NOTICE AND AGENDA
Regular Meeting
Idaho Springs Planning Commission
1711 Miner Street, City Hall
Thursday, September 22, 2022 – 6:00 p.m.

ITEM: FINAL DEVELOPMENT PLAN FOR A PUBLIC FACILITY IN THE FORM OF
A TRANSPORTATION MAINTENANCE FACILITY LOCATED AT 320
CHICAGO CREEK ROAD, SOUTH OF THE CLEAR CREEK SCHOOL
DISTRICT'S BUILDING 103(FORMER MIDDLE/HIGH SCHOOL).

To: Jerad Chipman, City Planner, City of Idaho Springs

Review comments were provided in the PDF named: *HDR Review - 20220804 CCSD TMF - Civil Plans - 100%CD Set*.

TRANSITION CURB

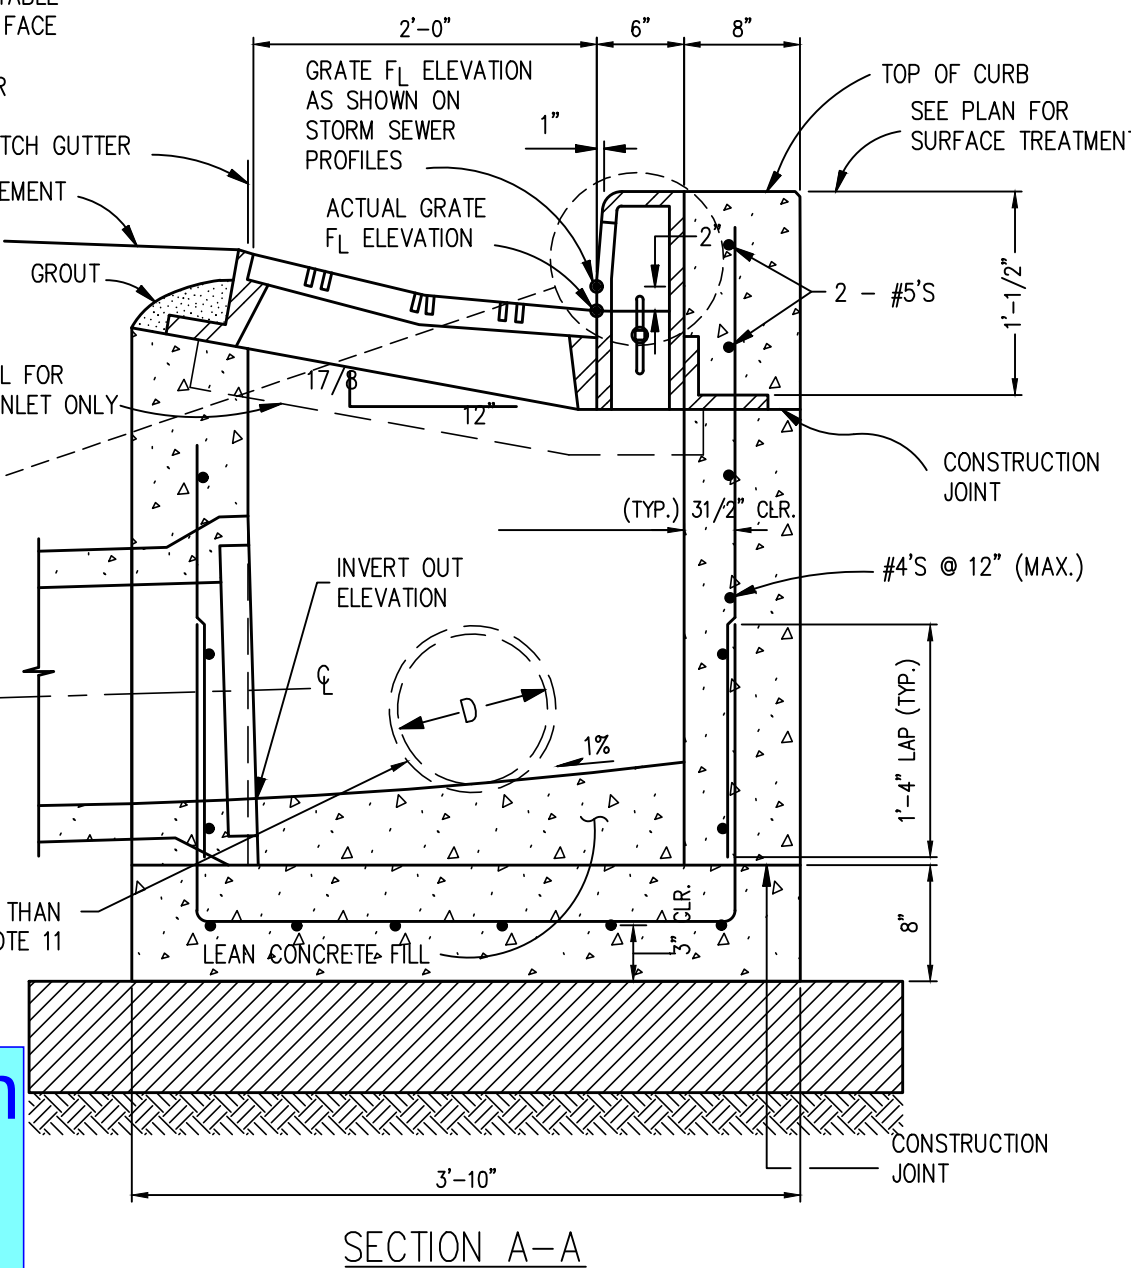
2' transitions in Idaho Springs Standards

FIRE HYDRANT ASSEMBLY DETAIL 4 C200

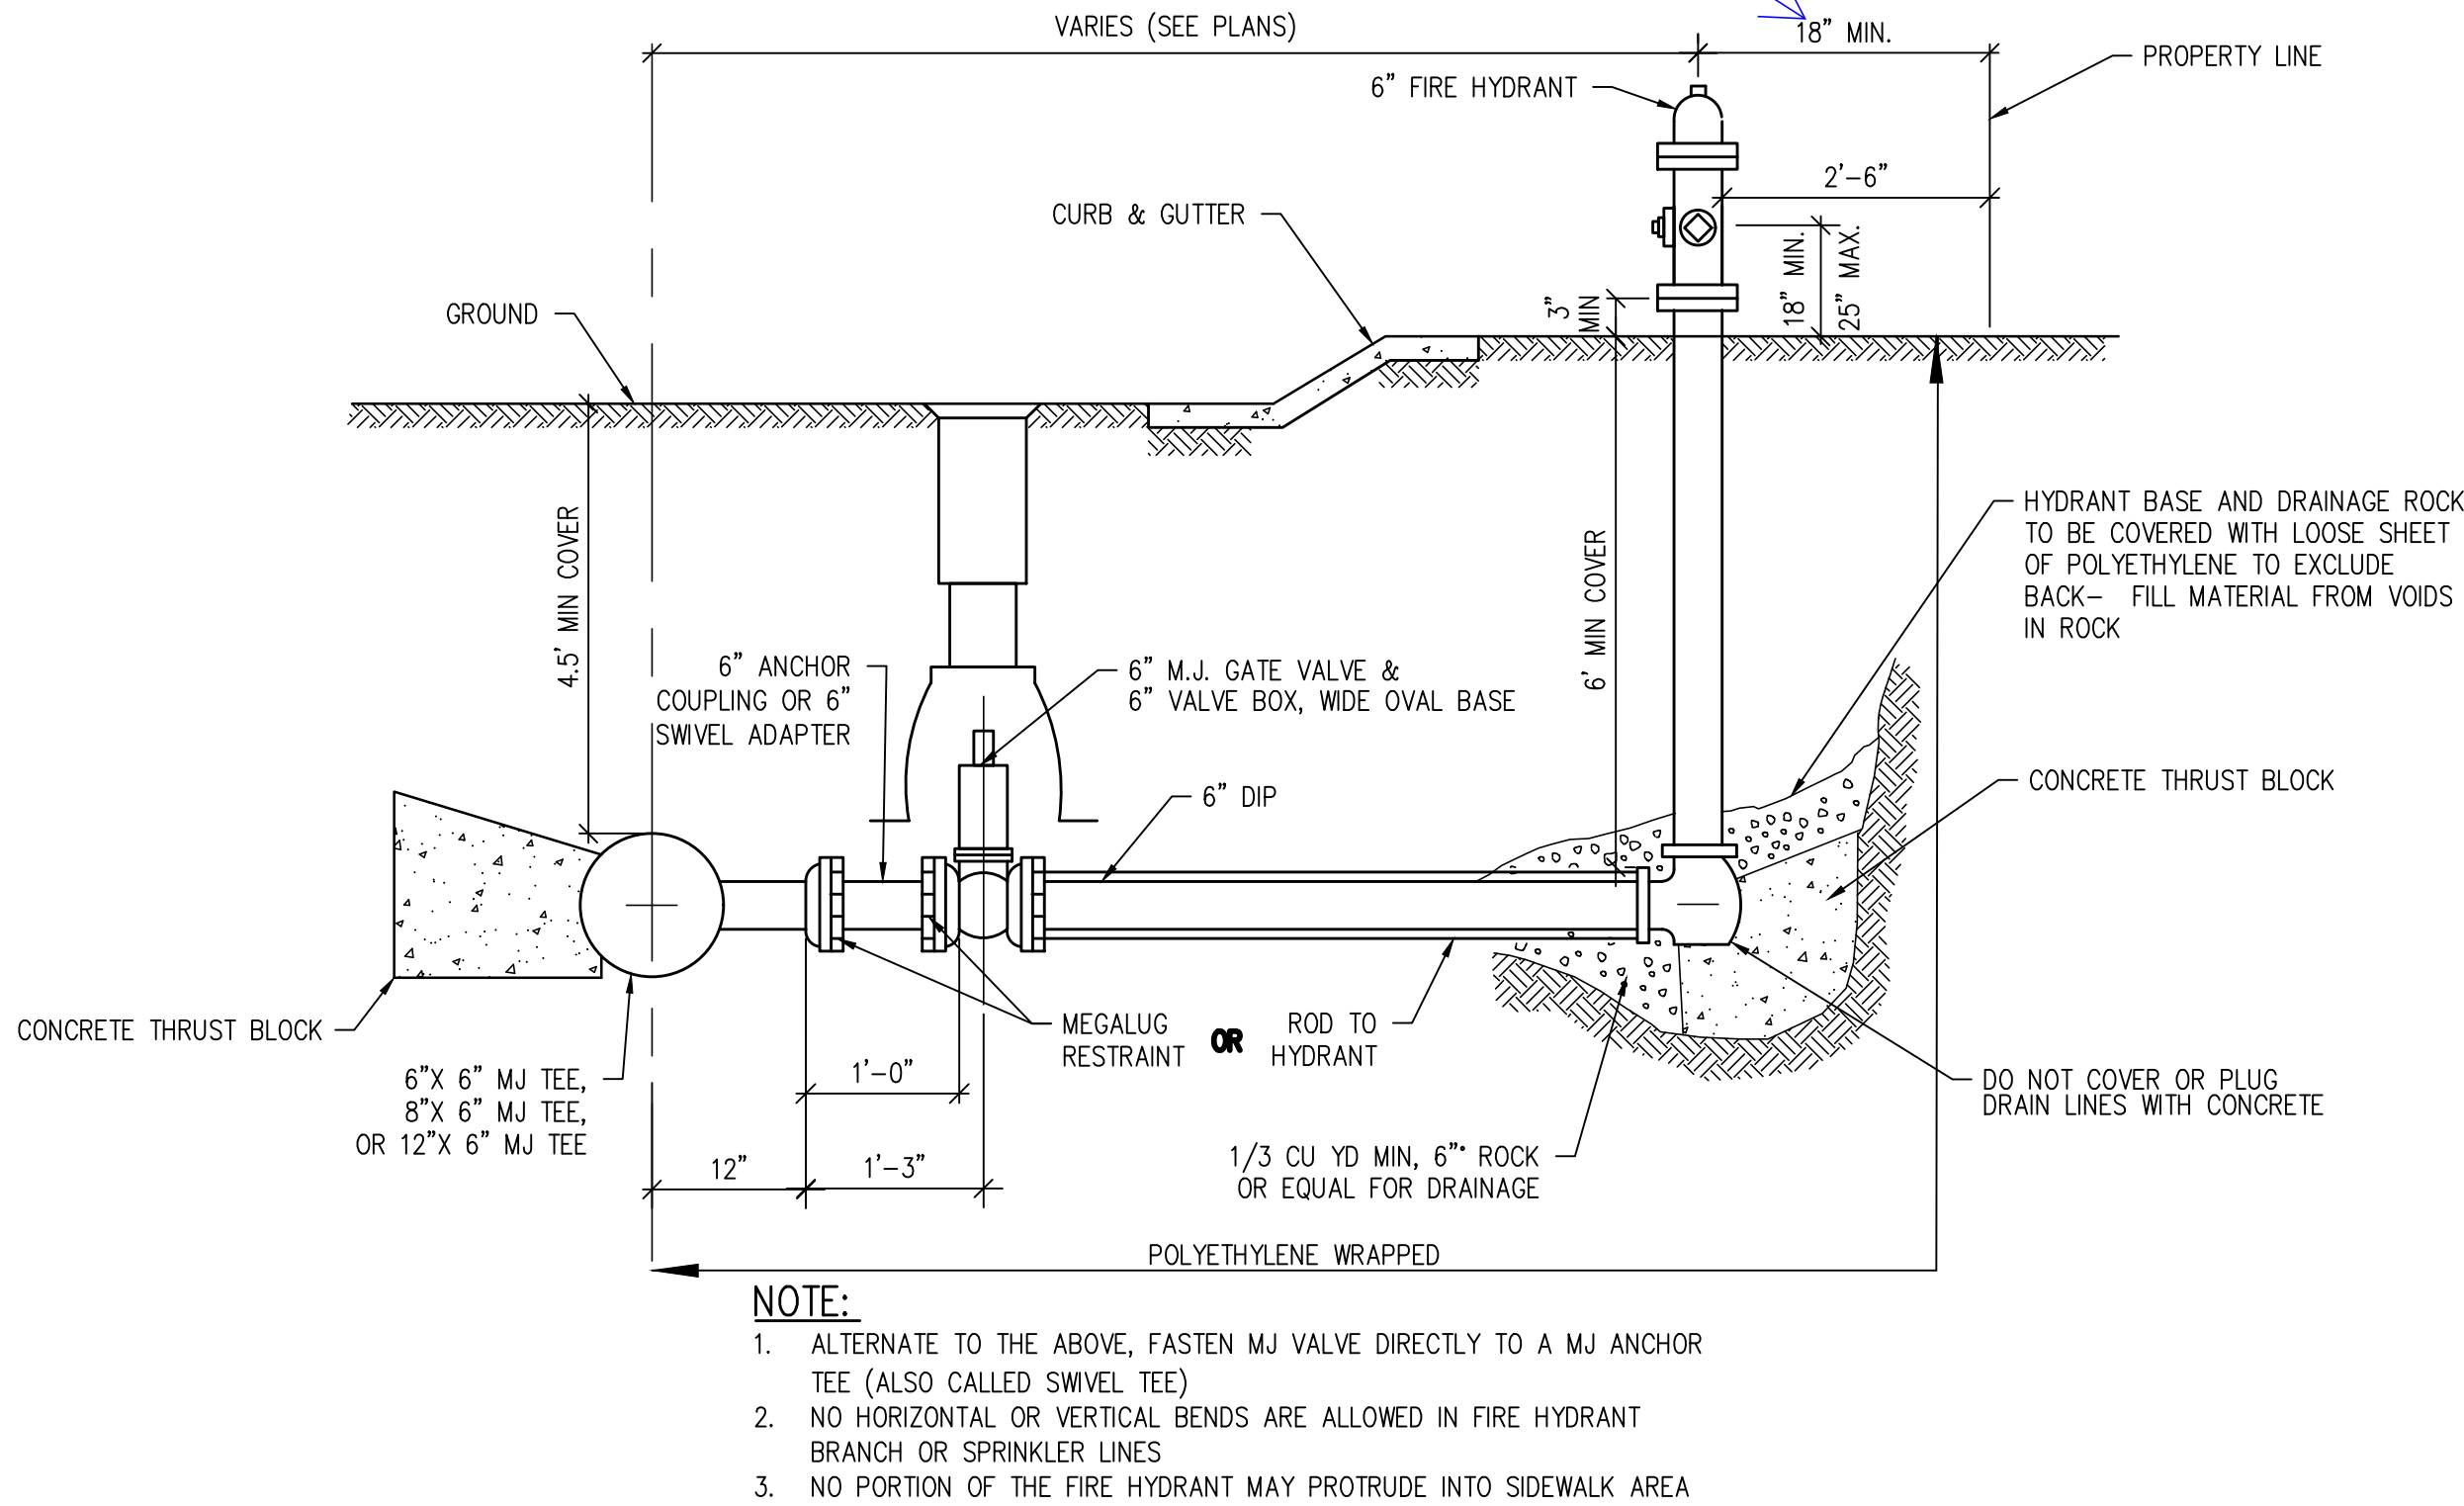
5' min per Idaho Springs standard

**HORIZONTAL
CONTROL
PLAN**

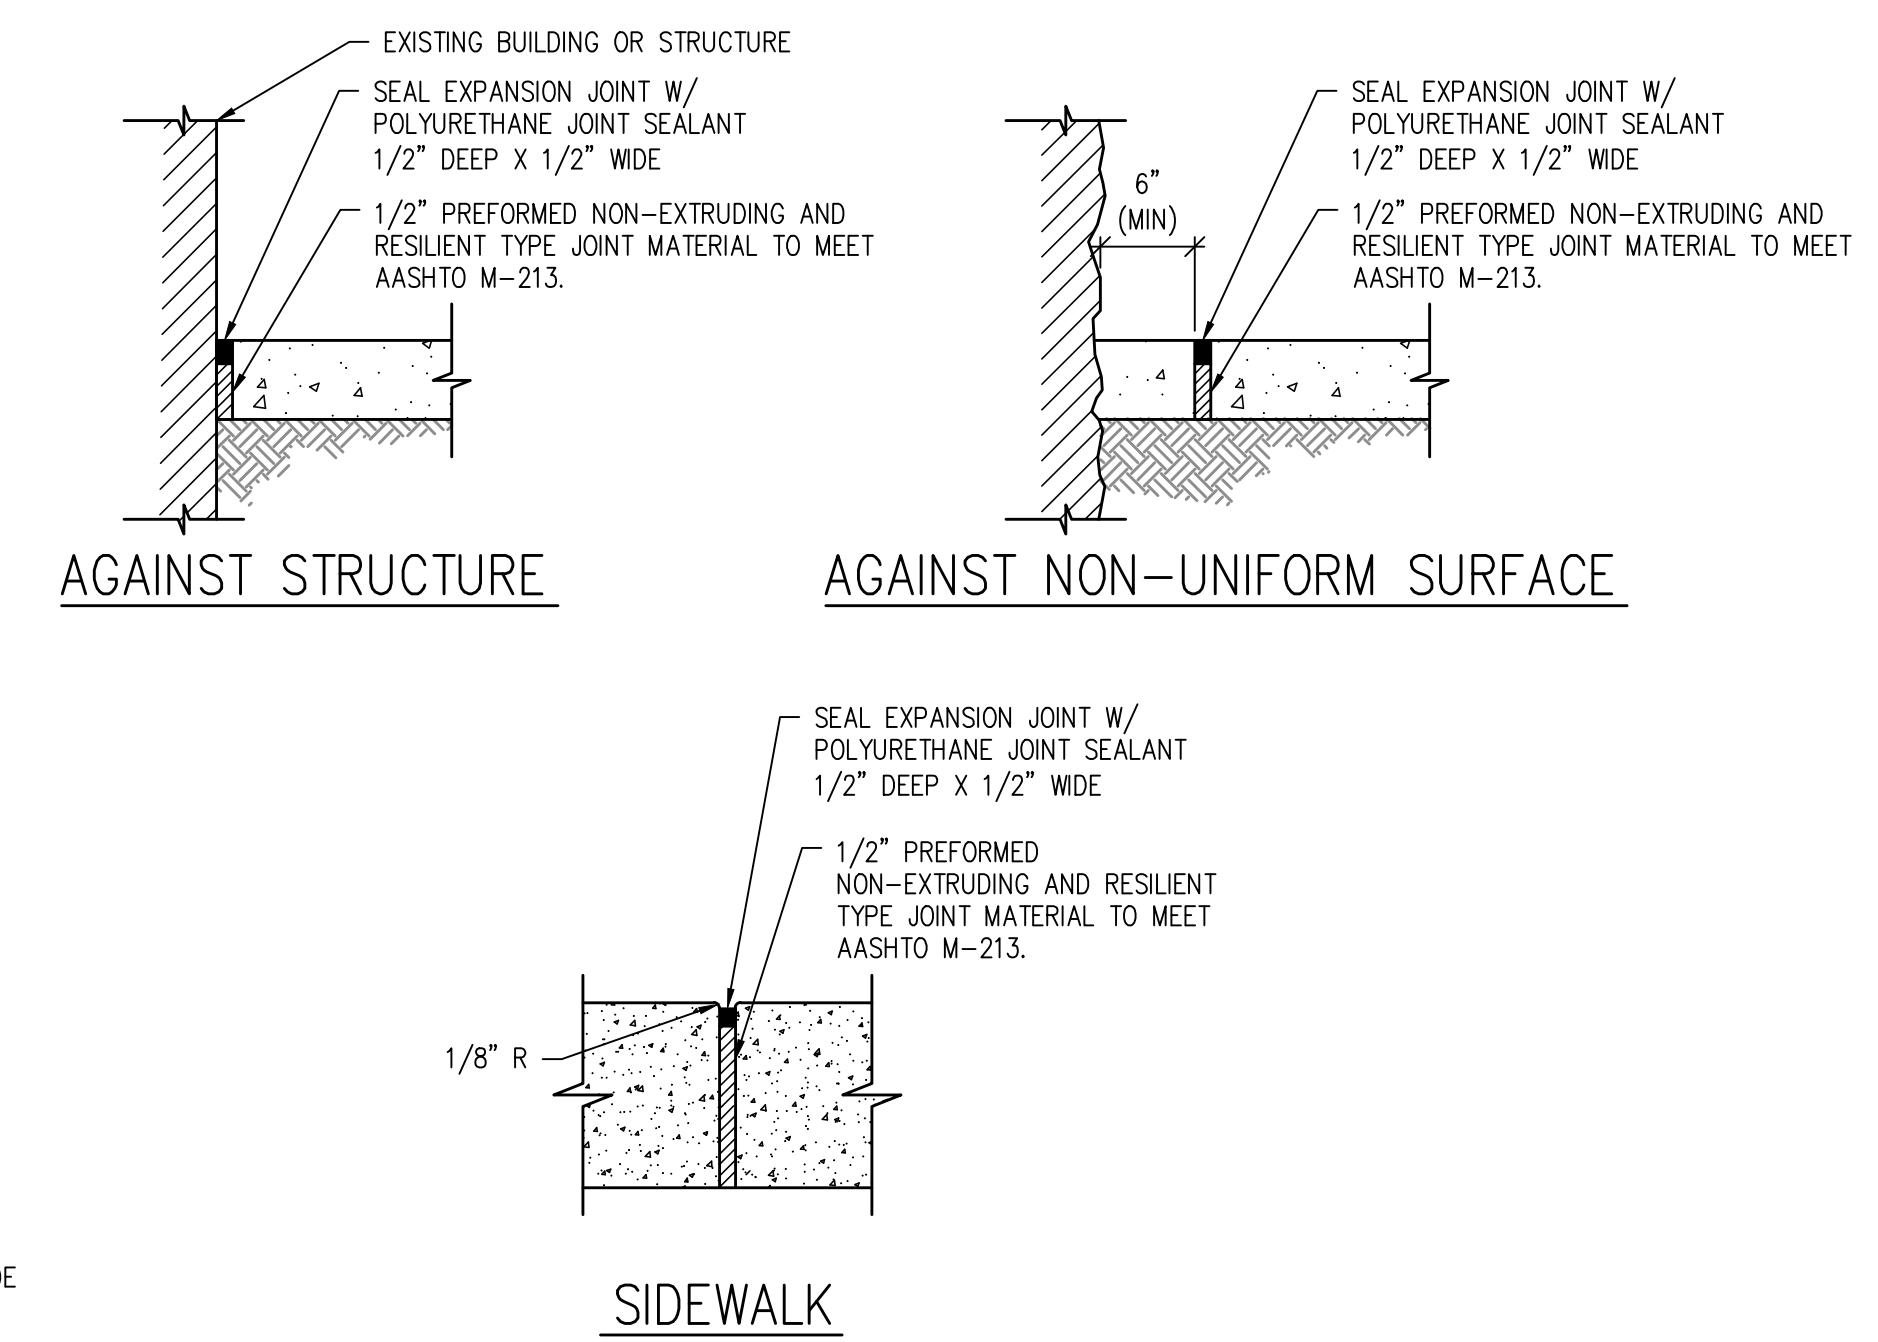
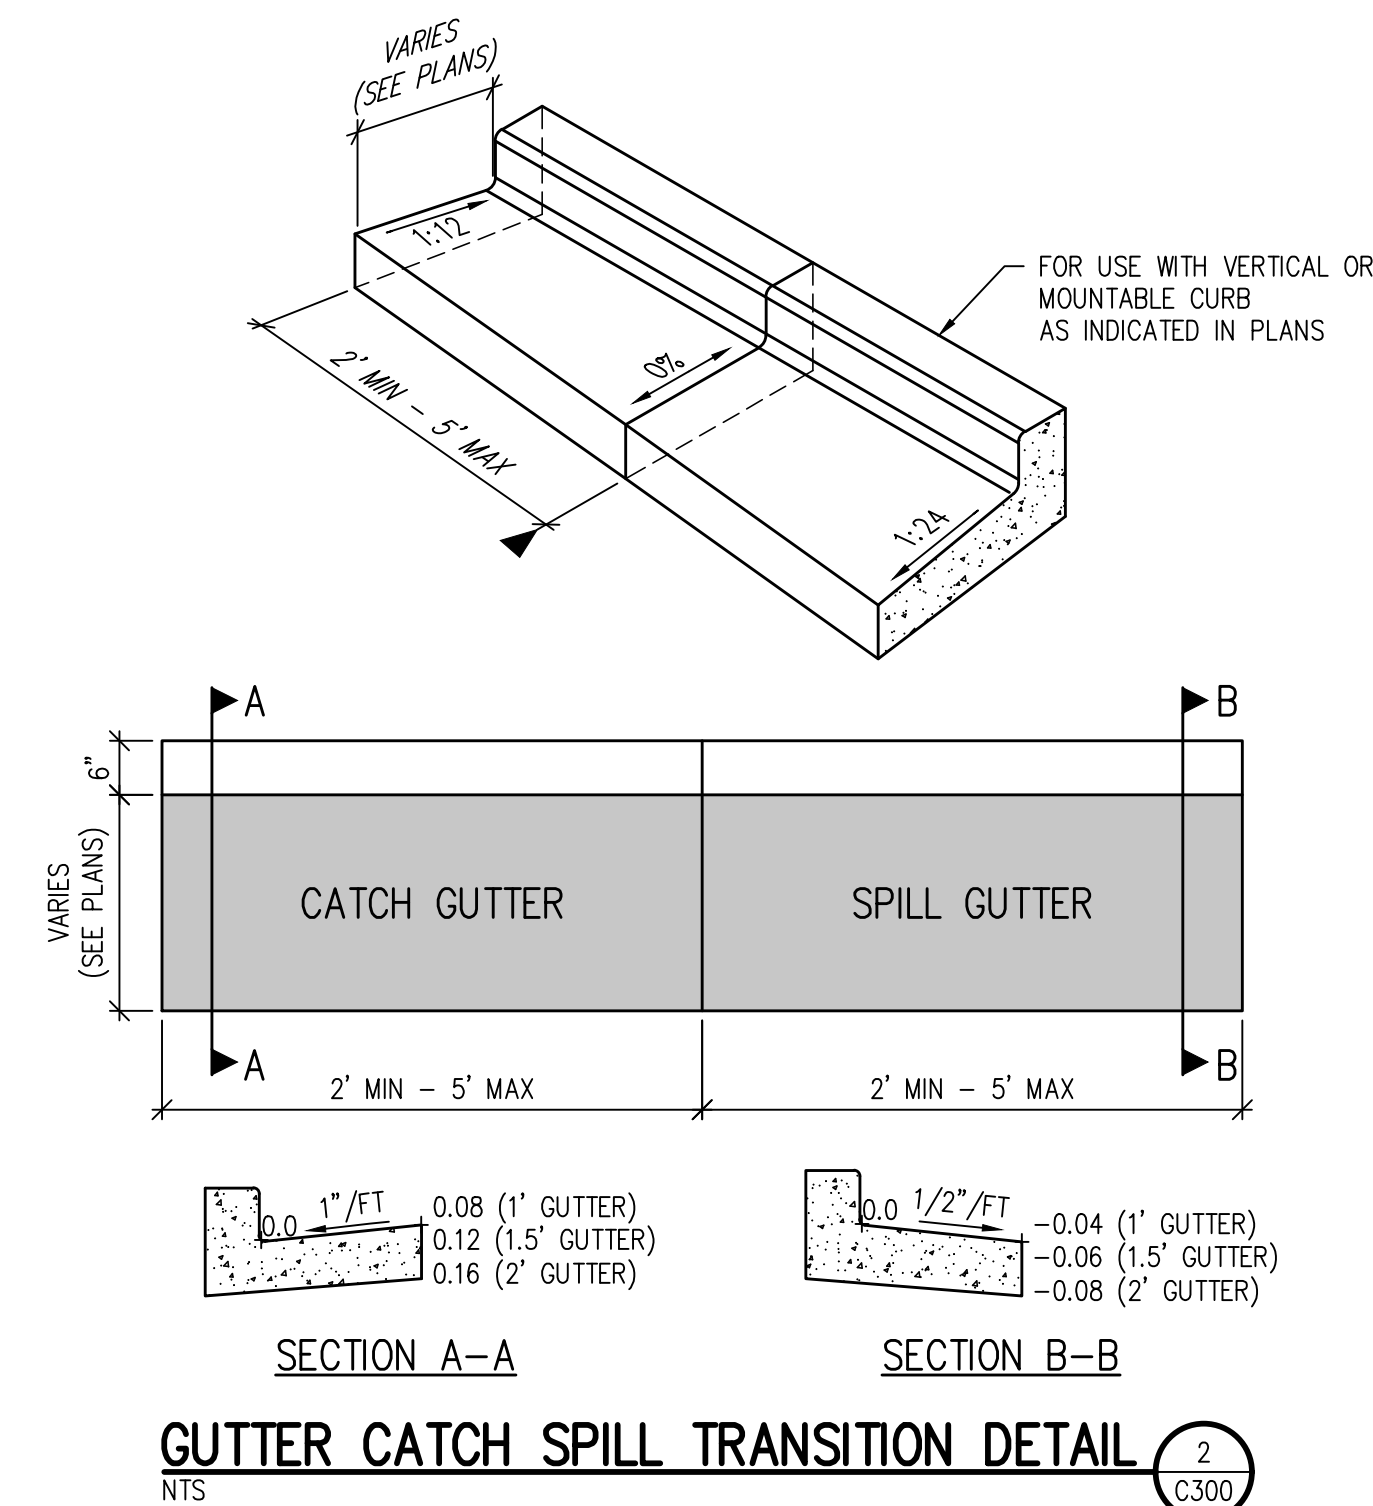
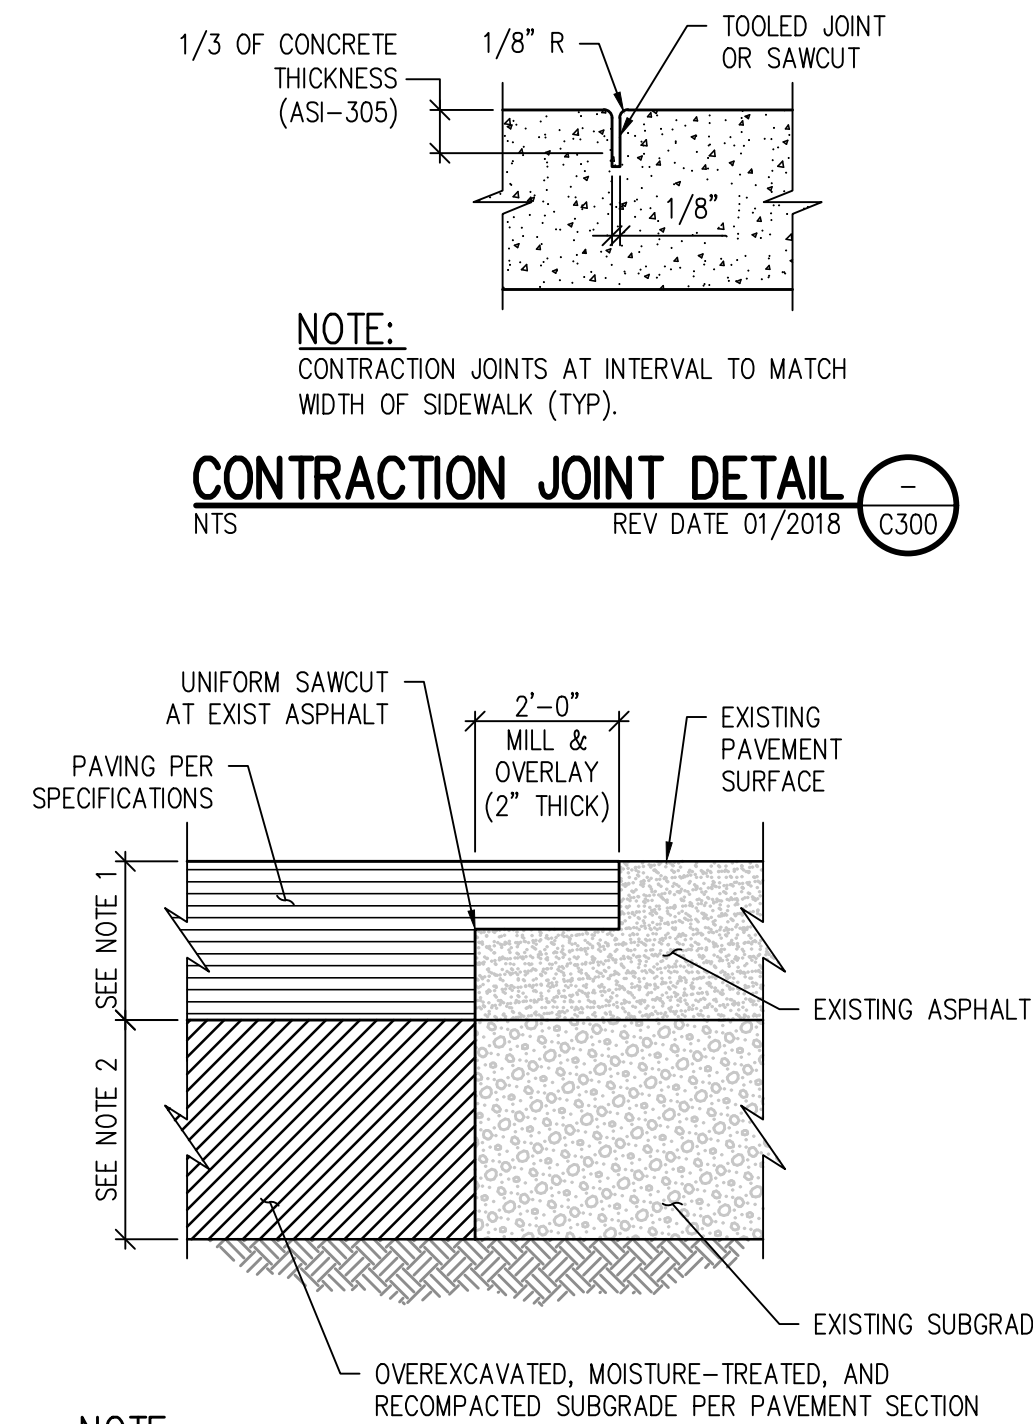
Confirm appropriate sized
for conveyance.
